COMMITTEE OF THE WHOLE MAY 16, 2005

**SITE DEVELOPMENT APPLICATION
PETRO-CANADA
FILE DA.04.043**

**Approved Site Plan
(October 27, 1997)**

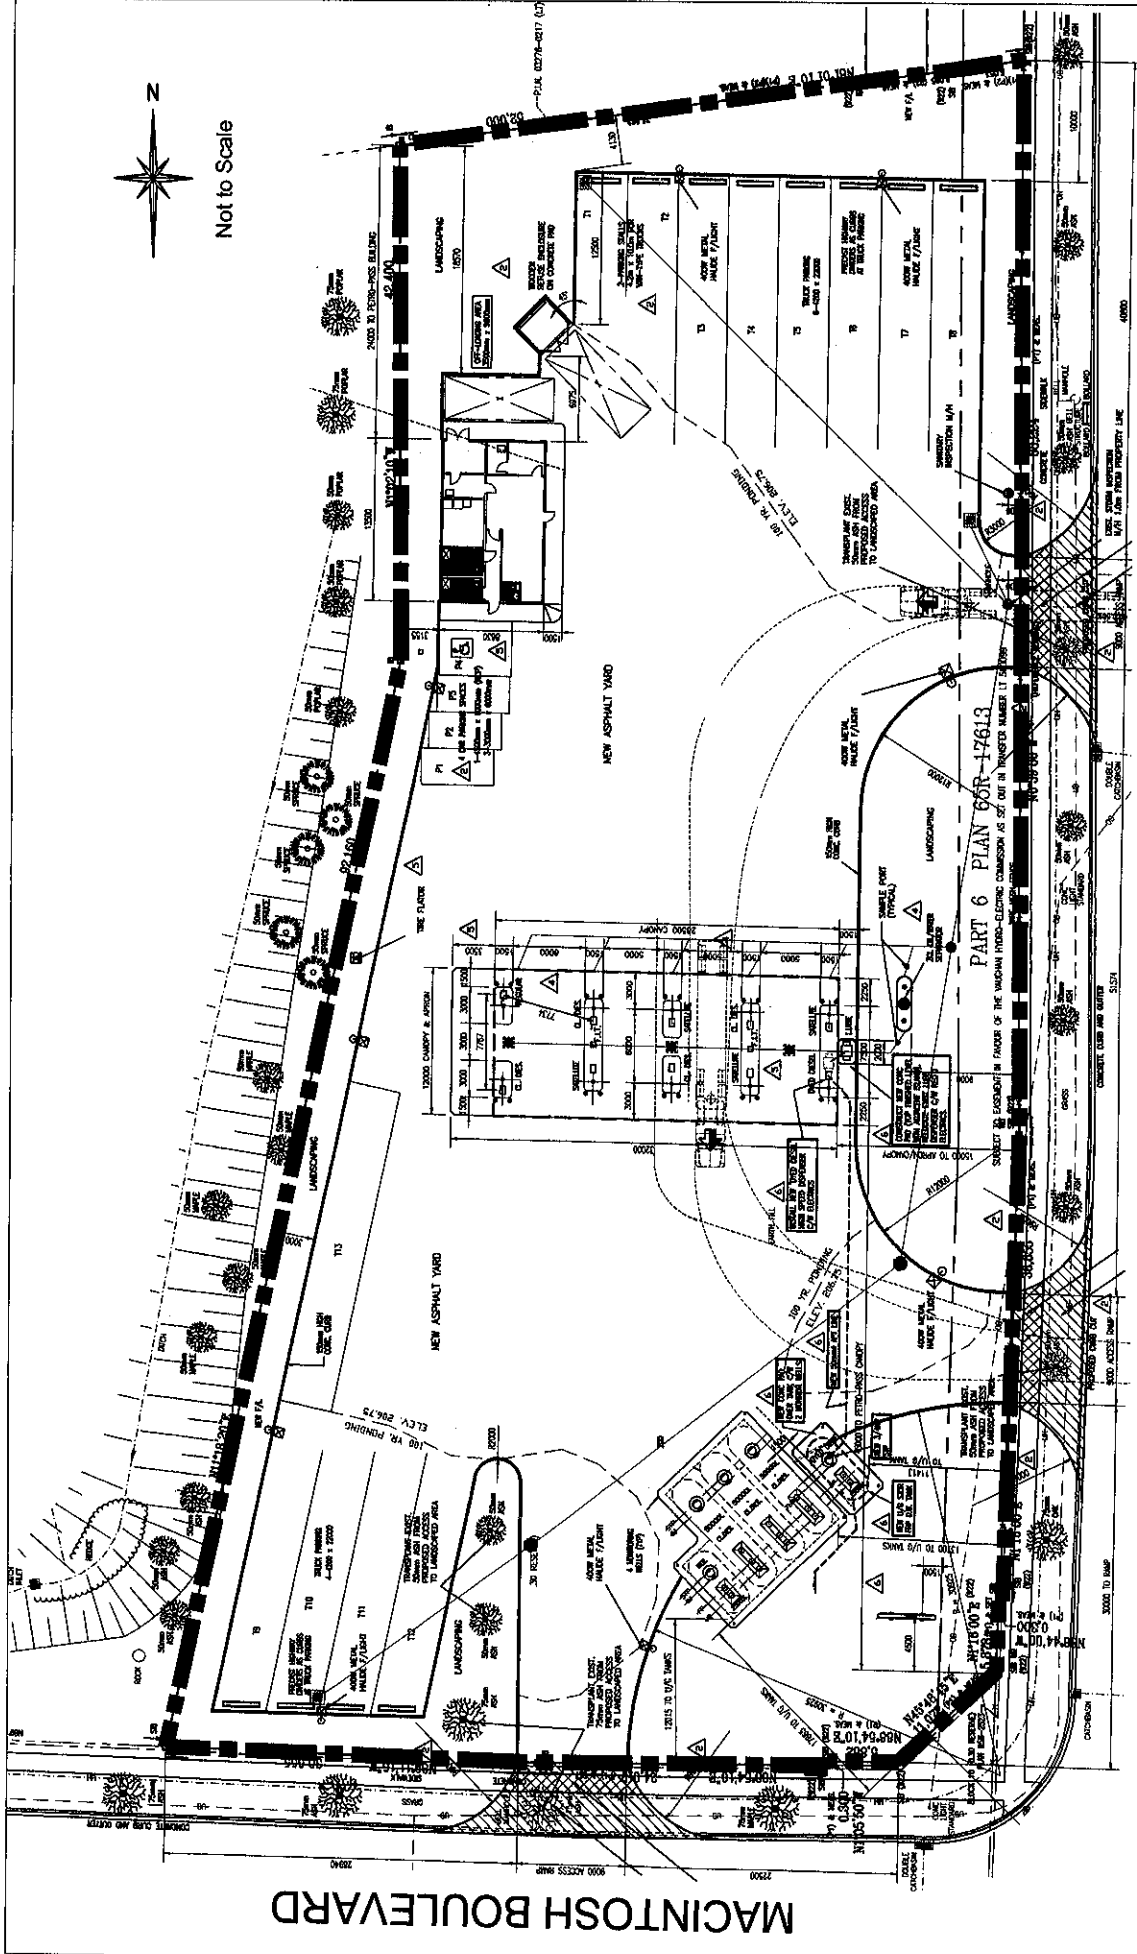
The subject lands are developed in accordance with the approved site plan (Attachment #2), which shows a gas bar in the centre, a Petro Pass building along the westerly property line, and parking areas at the northeast and southwest corners of the site. The proposed revisions consist

Proposed Revisions to Site Plan

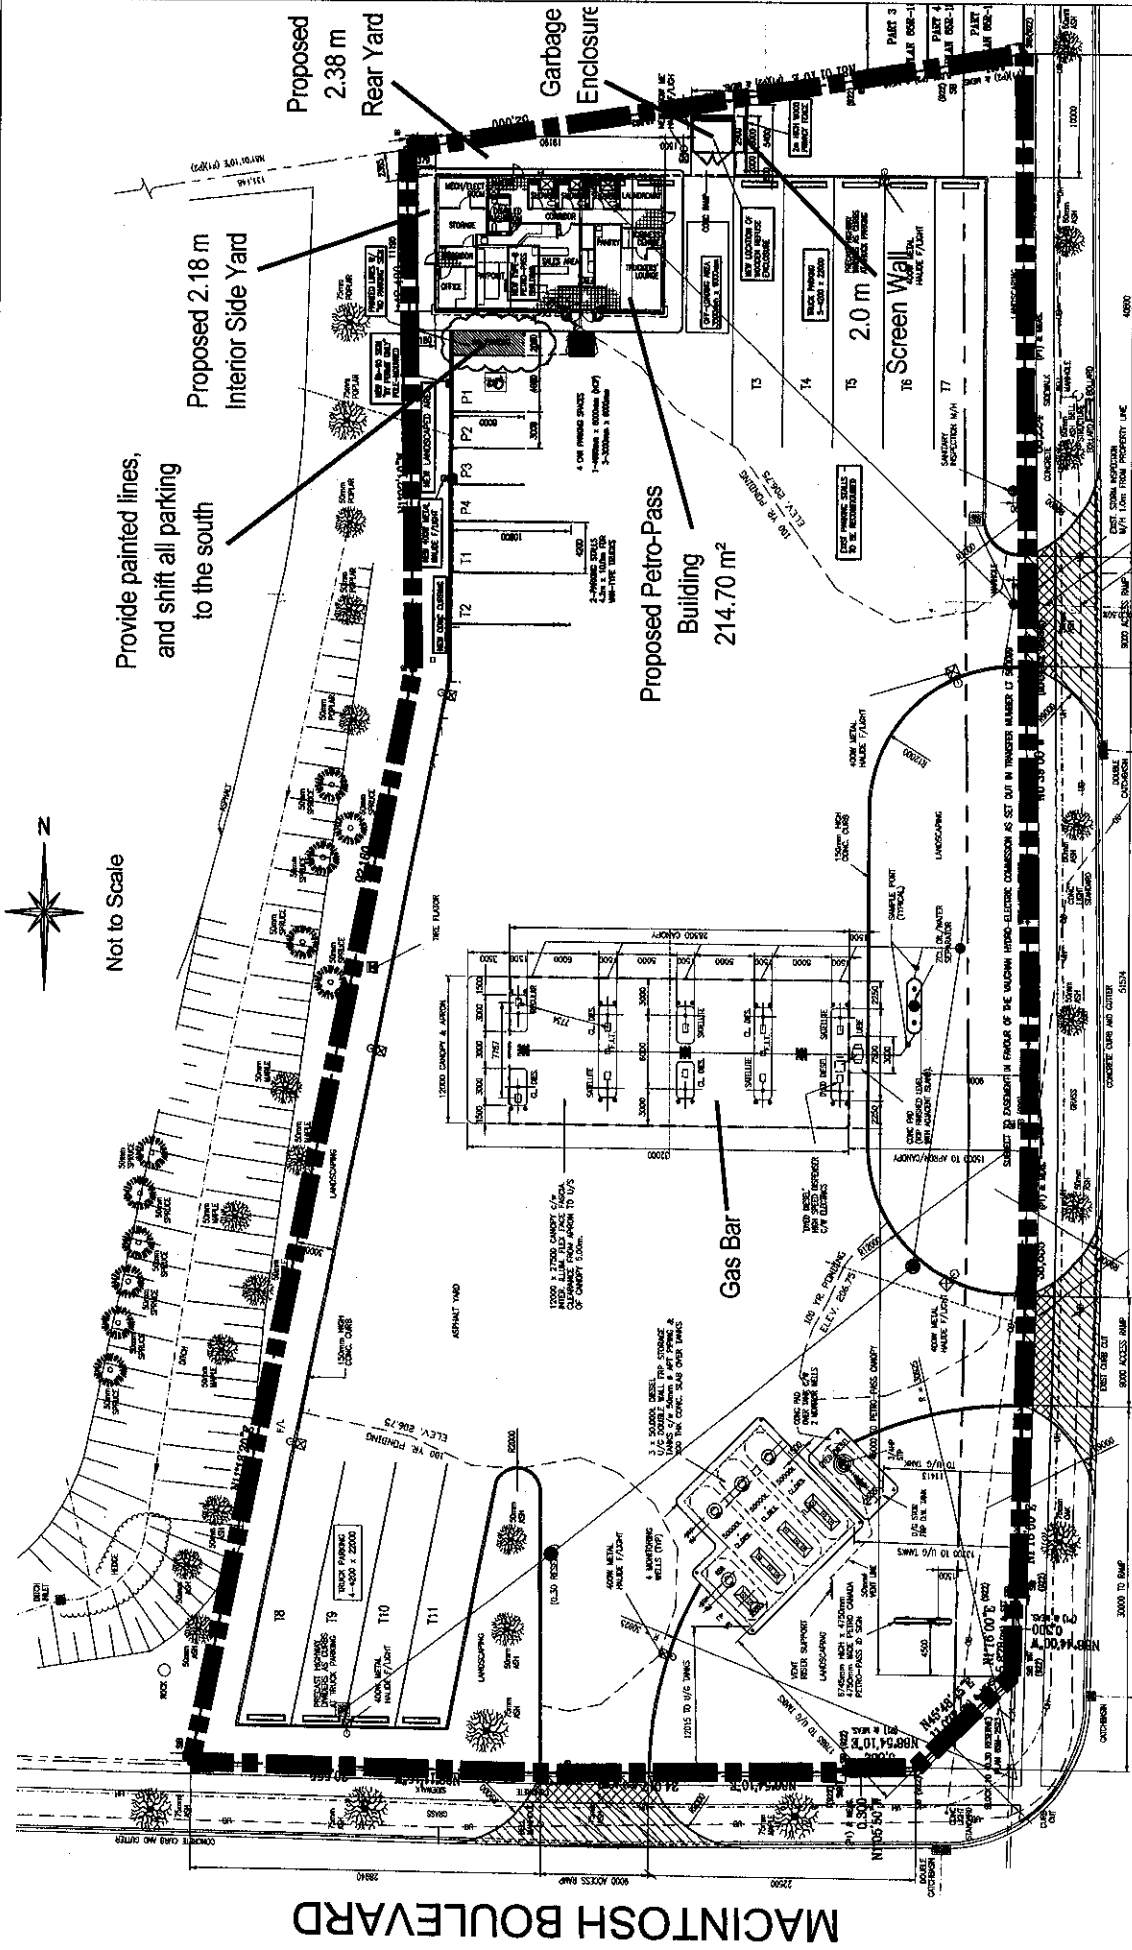
of the relocation of the customer service “Petro-Pass” building to the northwest corner of the site and an increase in gross floor area from 114.75 m² to 214.7 m². Four car parking spaces, including one space for disabled persons, and two van-sized parking spaces will be relocated to the south side of the proposed building. The garbage enclosure will be relocated to the east side of the proposed building, with a wood privacy fence to screen the enclosure from Creditstone Road. The final site plan shall be to the satisfaction of the Development Planning Department.

Three full-movement access points serve the site, including two on Creditstone Road and one on MacIntosh Boulevard. The site is developed with 18 parking spaces. The applicant is proposing a 3 space reduction in parking from 18 to 15 spaces. By-law 1-88 calculates the required parking for the site as follows:

Provide painted lines, and shift all parking to the south

Proposed Elevations

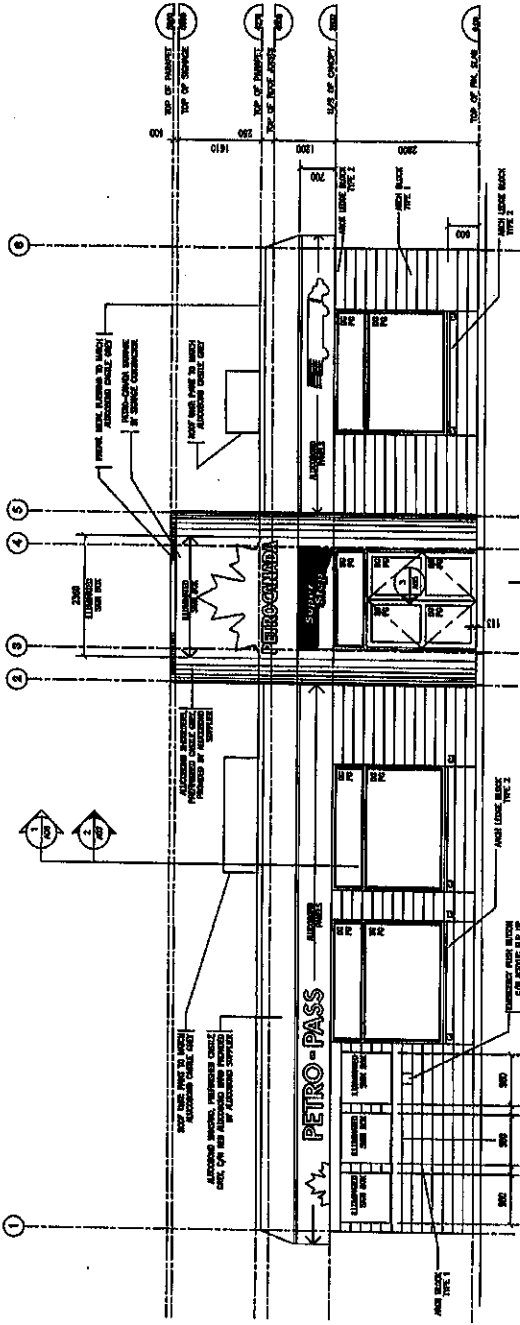
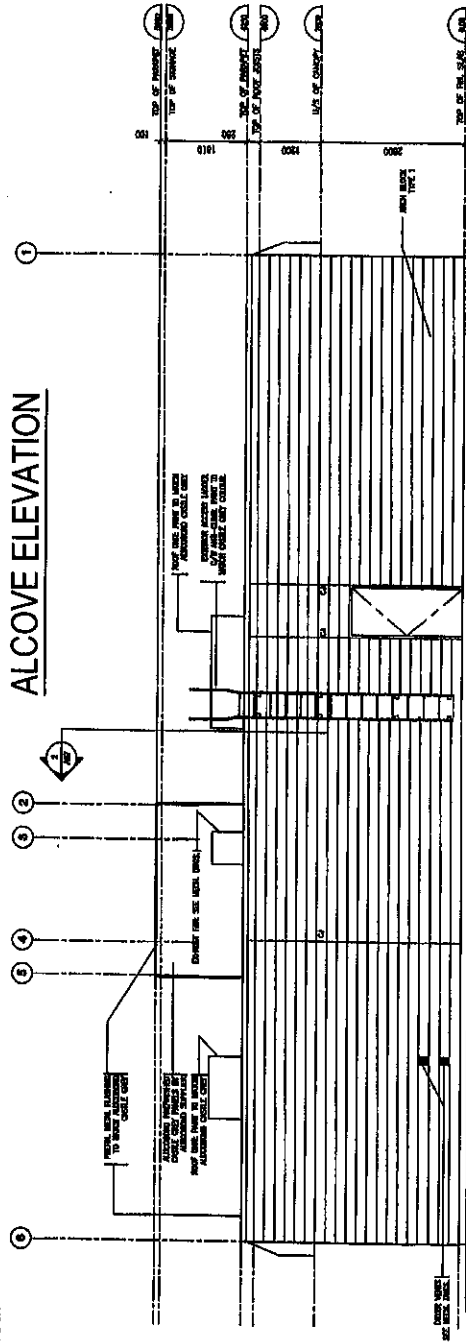
The proposed building (Attachments #4 and #4a) will be constructed to a height of 4.25m, which is a 0.65m increase from the previous approved height of 3.6m. The roof-top mechanical equipment, including the parapet and the corporate signage above the entrance door, increases the height to 5.9m.

The building material consists of medium grey-coloured architectural block, in the corporate colours of Petro Canada. The main double entrance door is located on the south elevation facing MacIntosh Boulevard, with a Petro Canada red and white corporate logo above. Grey vertical metal panels frame the entry with ground floor windows on either side. A wall-mounted “Petro-Pass” sign is located above three small illuminated sign boxes on the south elevation.

The east elevation, facing Creditstone Road has two windows and a man door. An exterior ladder is located on the north elevation. The roof-top mechanical equipment on the building is screened from the view of the street. The final building elevations shall be approved to the satisfaction of the Development Planning Department.

Proposed Landscape Plan
 Part of Lot 8,
 Concession 4
 APPLICANT: PETRO - CANADA
 (K:\DFT\1 ATTACHMENTS\DA.04.043)

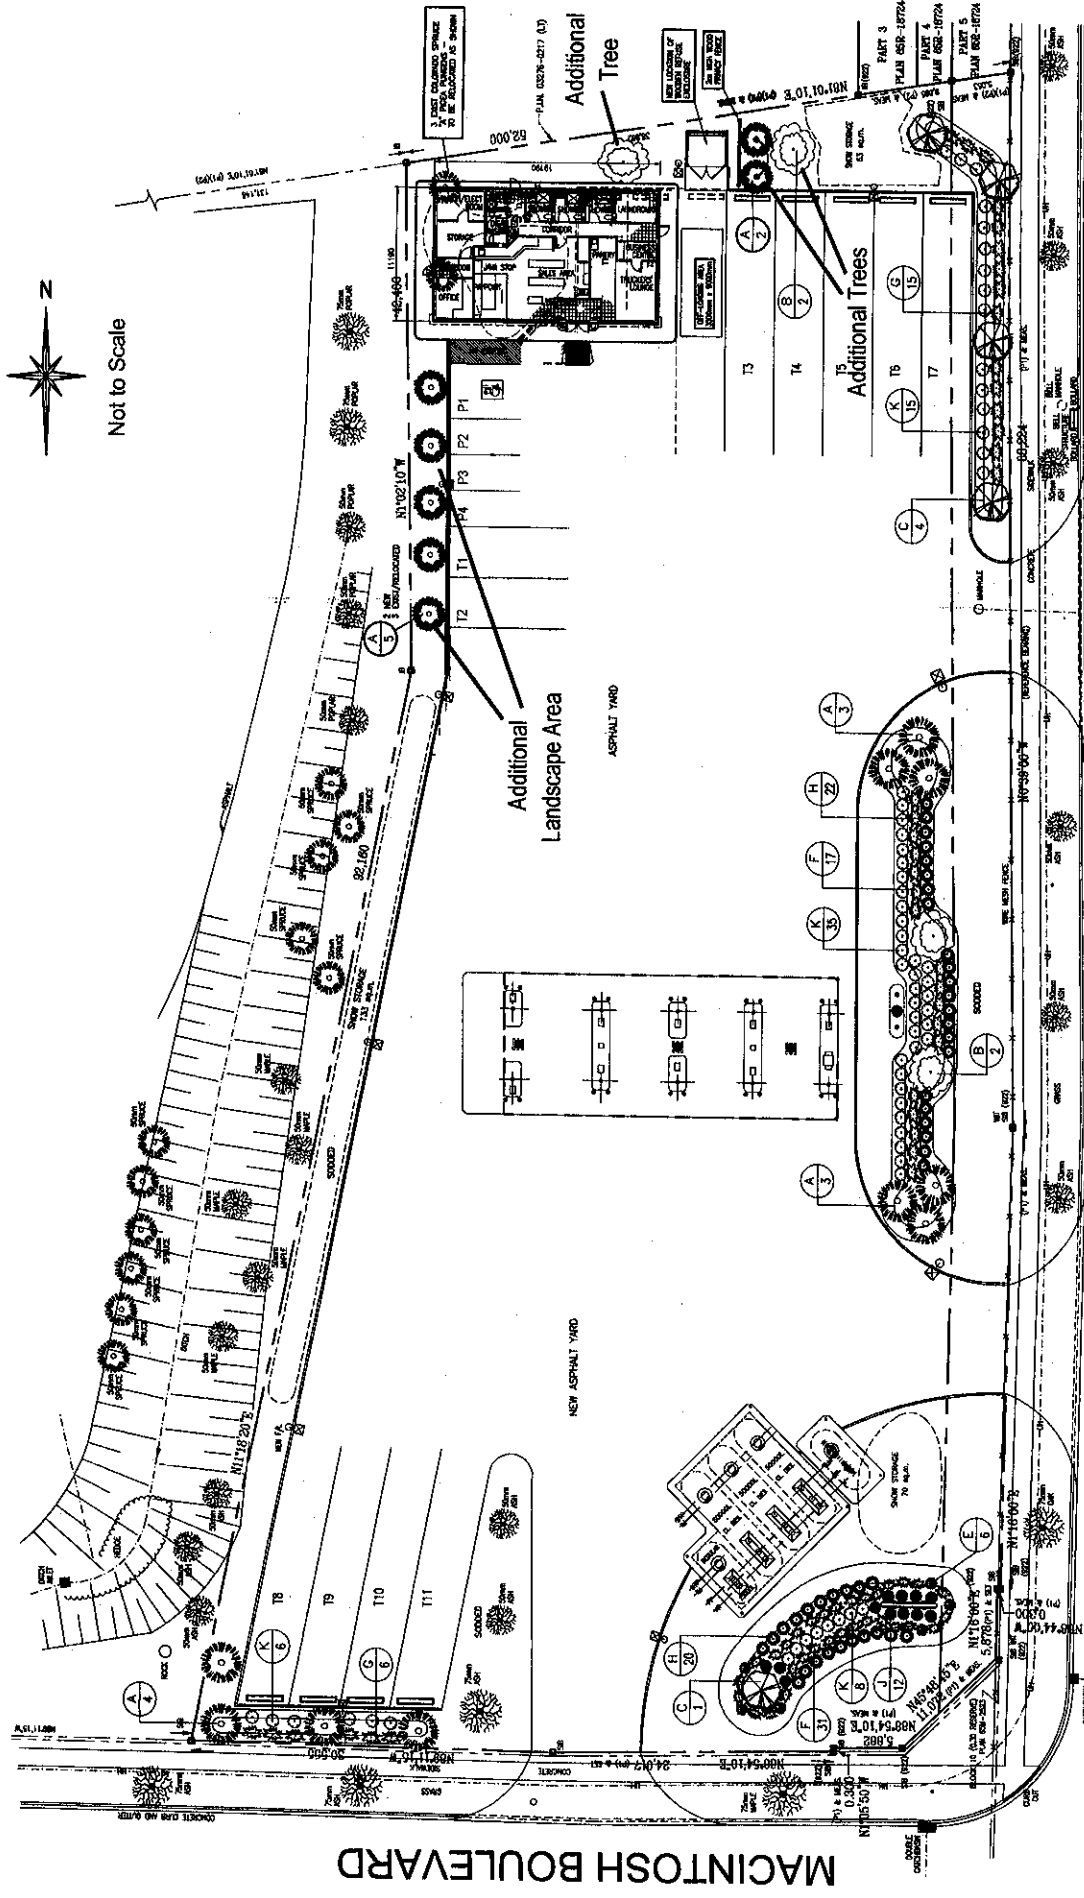
The periphery of the site is landscaped with a variety of coniferous and deciduous trees and shrubs. Additional trees will be added along the northerly and westerly property lines and on the east side of the garbage enclosure to provide further screening from Creditstone Road. The

applicant is proposing a decrease in the total landscaped area from 30.1% to 27%, which is well above the minimum 5% landscaping requirement in an Employment Area Zone under By-Law 1-88. The final landscape plan shall be approved to the satisfaction of the Development Planning Department.
